Final Technical Support Document

Missouri Area Designations for the 2010 SO₂ Primary National Ambient Air Quality Standard

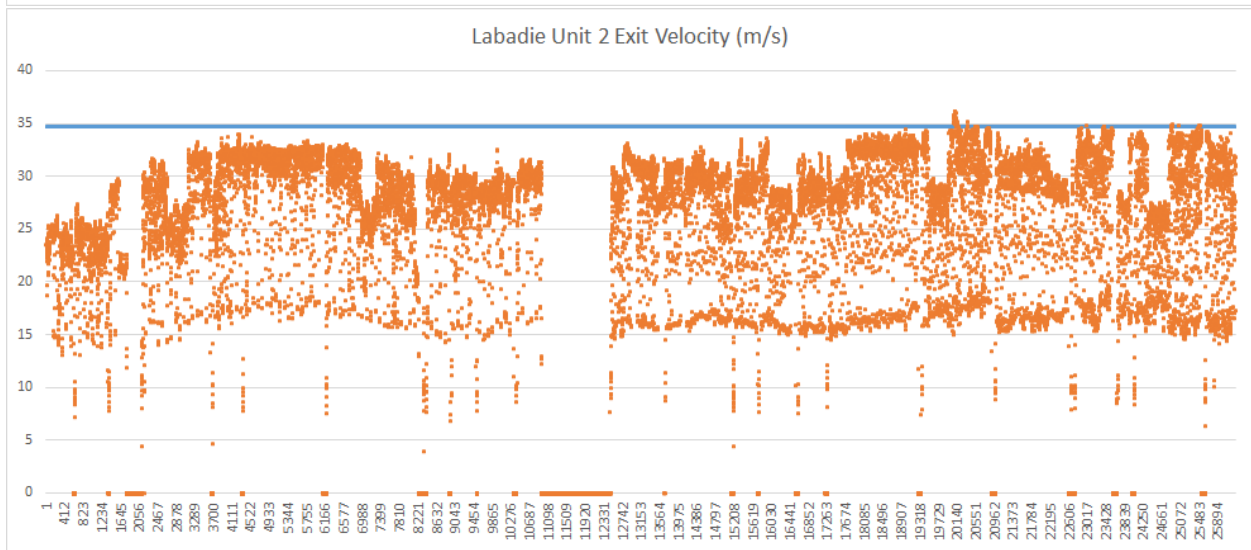
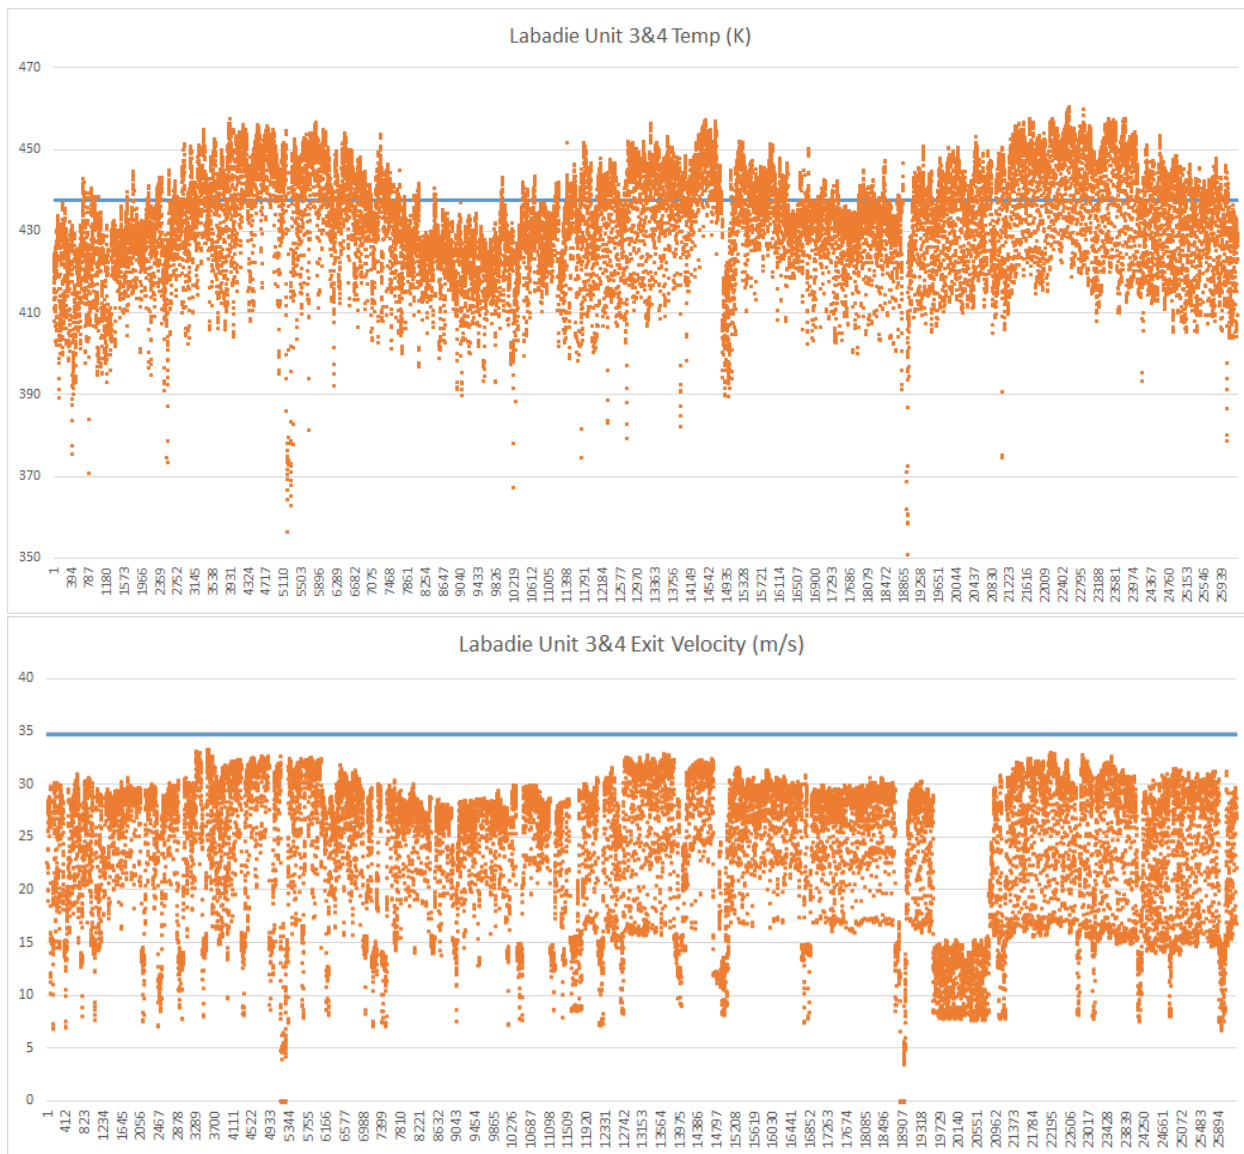
In the first scenario, Missouri indicated that the only change made to the modeling submitted in the state's original recommendation was to use 2013-2015 hourly emissions and meteorological data rather than 2012-2014 data. This scenario resulted in a decrease in the approximate design value of the area from 234 $\mu\text{g}/\text{m}^3$ (or 90 ppb) to 201 $\mu\text{g}/\text{m}^3$ (or 77 ppb).

In the second scenario, Missouri modeled units 3 and 4 as described above but with a single release point as a merged plume. This modeling scenario resulted in an approximate design value of 175 $\mu\text{g}/\text{m}^3$ (or 67 ppb) which is less than the 2010 1-hour NAAQS of 75 ppb. Missouri justified using a merged plume for units 3 and 4 by citing two EPA Model Clearinghouse Information Storage and Retrieval System records (MCHISRS), 91-II-01 and 96-V-10, which describe situations in which multiple stacks/flues were allowed to be modeled as a single source. Because units 3 and 4 at Labadie are vented through two flues contained in a singular outer annulus or stack, Missouri believes these flues are similar to those addressed in these two MCHISRS records. These two MCHISRS records suggest that if the flues/stacks are closer together than their respective widths/diameters they may be treated as a single source. This is based on the rationale included in the GEP stack height guideline regarding treating buildings that are closer than their individual widths as a single building when using the stack height formula. EPA concurs that modeling that uses merged the plumes for unit 3 and 4 can be used to inform our designation decision. A detailed discussion of Missouri's merged plume calculations is available in the Missouri April 19, 2016, comment letter and attachments. This information is included in the docket to this action.

In its new modeling analyses and the modeling analysis included in its September 25, 2015, submittal, Missouri used fixed inputs for the stack temperature and exit velocity. Ameren, during the comment period for the EPA's intended designation, provided hourly varying temperatures and corresponding exit velocities for 2013-2015. The EPA compared the hourly varying temperatures and exit velocities provided by Ameren to the fixed values used by Missouri and

determined that the fixed temperatures and exit velocities used by Missouri were generally higher than the actual stack temperatures and exit velocities during that period.

Because plume rise is dependent on temperature for buoyancy calculations and exit velocity for momentum calculations, Missouri's use of temperatures and exit velocities that were higher than the actual values reported by Ameren likely led to an overestimated modeled plume rise during most hours and could possibly under-predict concentrations. To compare the fixed values Missouri used in their modeling to the actual values reported by Ameren, the EPA developed the plots below. The blue line represents the fixed values used by Missouri and the orange dots represent Ameren's hourly varying values from their May 2, 2016 modeling analyses.

In summary, Missouri’s first modeling approach in their April 19, 2016, submittal was similar to their original September 25, 2015, modeling submittal. Missouri’s approach relies upon varying emissions hourly, using fixed stack parameters for temperature and exit velocity, and processing the surface characteristic parameters on a seasonal (e.g., fall, winter, spring, summer) basis. Missouri’s full modeling approach is described in the original submittal, and the only changes in the updated MNR modeling include using 2013-2015 emissions and meteorology along with the merging of Units 3 and 4. The EPA notes that, while Missouri’s newest modeling and their approach attempts to follow the EPA modeling TAD, the EPA questions the validity of the magnitudes for the fixed stack parameters currently being used, especially the exit velocity values for the merged Units 3 and 4, which appear to be overestimated on average by 25%. The overestimation results in a likely significant overestimation of the plume rise of emissions from Labadie and, consequently, a likely under-prediction of the ambient concentrations. While the modeling TAD generally supports the use of fixed stack parameters where appropriate, the fixed parameters should be representative of actual conditions, and in this case, the values used in the

Missouri modeling appear higher than the actual hourly values provided by Ameren. Consequently, the EPA does not believe that Missouri’s modeling provides sufficient information to determine whether the area is meeting the NAAQS, and it is not certain that correction of the fixed parameters would yield a clear indication of whether the area is meeting the NAAQS.

Figure 3. 2013-2015 exit velocities for merged unit 34.

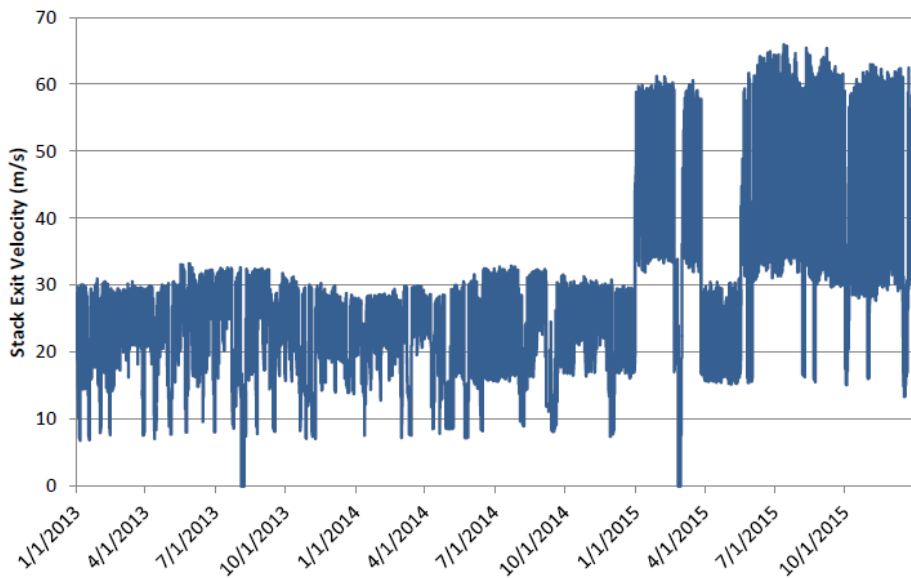
Figure 2: Hourly Varying Exit Velocities for the Merged Units 3 and 4 Used in Ameren modeling submitted on March 29, 2016. (Figure 3 in the Sierra Club’s April 19, 2016 Submittal)

Ameren's May 2, 2016 submittal included four additional modeling runs that corrected the 2015 exit velocity error and also addressed other comments Sierra Club made on surface meteorological data characteristics.

The EPA reviewed these four additional Ameren modeling runs. Unlike the uncorrected State modeling for which it is uncertain whether corrected stack parameters would indicate whether the area is meeting the NAAQS, Ameren's corrections resulted in a specific design value increase that still suggested NAAQS attainment. However, the EPA's review of Ameren's updated modeling discovered an additional error related to the processing of surface parameters that was included in all 18 modeling runs that Ameren submitted in response to our proposed designation of nonattainment. Ameren attempted to process AERSURFACE on a monthly basis for 12 spatial sectors to estimate the surface characteristics for the 2013-2015 modeling period. However, during the AERSURFACE processing of the monthly by sector data, Ameren erred in the processing of the monthly data for the output of the Bowen Ratio. This error is related to the Bowen ratio lookup for a wet, dry, or average period. The monthly temporal resolution approach Ameren attempted to implement is acceptable, and, if performed correctly, is likely more representative than assuming average moisture conditions across the year. However, this error caused the monthly Bowen ratio to be incorrect for many hours in each month. The daytime Bowen ratio, an indicator of surface moisture, is the ratio of sensible heat flux to latent heat flux and, together with albedo and other meteorological observations, is used for determining planetary boundary layer (PBL) parameters for convective conditions driven by the surface sensible heat flux. Errors in the PBL parameters will result in inappropriate dispersion calculations invalidating all modeling with this error. This error can be graphically visualized by plotting the Bowen ratio for any given month in the Ameren AERMET surface file. An example is given below in Figure 3 for the month of December 2015 from the Ameren May 2, 2016 modeling submittal.
